# Work Order ID 125684

Item Name: Crosstube Turning Detail

<b>DART AEROSPACE LTD</b>		<b>Work Order:</b> 125684
<b>Description:</b> Crosstube Assembly		<b>Part Number:</b> D407-667-145
<b>Inspection Dwg:</b> D407-667-145 Rev: C		<b>Page 1 of 2</b>

DRAWING NO. D407-667-145	TITLE CROSSTUBE ASS'Y (407 HIGH FWD)	REV. C	<b>DART AEROSPACE LTD ENGINEERING ORDER</b>		D.E.O. NO. D407-667-145-C-1	SHEET NO. SHEET 1 OF 1	SCALE NTS
DRAWN <i>qp</i>	CHECKED <i>ASS</i>	MFG. APPR. <i>IB</i>	APPROVED <i>WD</i>		DE APPR. <i>HA</i>		
DATE 11.07.15	DATE 11.07.22	DATE 11.07.22	DATE 11/07/22		DATE 11.07.21

**DETAIL P**  
BONDING STRAP INSTALLATION 2 PL

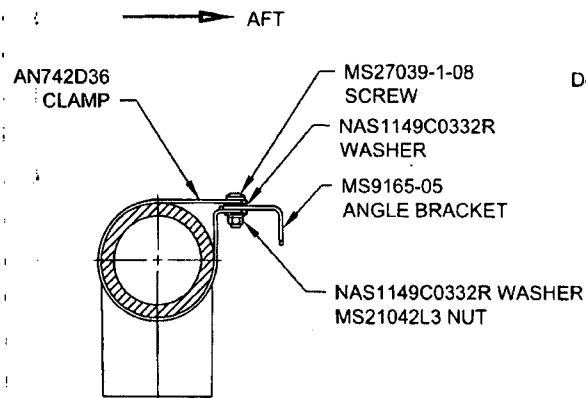
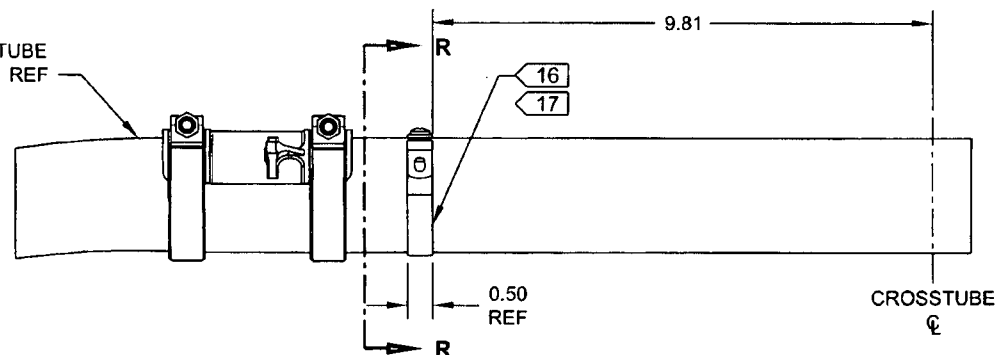
ADD ELECTRICAL GROUNDING STRAP

ITEM	QTY -145	PART NUMBER	DESCRIPTION
1	X	D407-667-145	CROSSTUBE ASSEMBLY (407 HIGH FWD)
⚡			
10	2	AN742D36	CLAMP
11	2	MS9165-05	ANGLE BRACKET
12	2	MS21042L3	NUT (OR MS21042-3)
13	2	MS27039-1-08	SCREW
14	4	NAS1149C0332R	WASHER (OR AN960C10L)

- 16) MASK AREA UNDER CLAMP PRIOR TO PAINTING
- 17) SEAL EDGES WHERE AN742D36 CLAMP MEETS WITH THE CROSSTUBE USING SIKAFLEX-241/-291 OR MIL-S-8802 CLASS B2 OR PROSEAL 890 SEALANT
- 18) PERFORM RESISTANCE CHECK TO ENSURE MAX RESISTANCE IS 10 MILLIOHMS
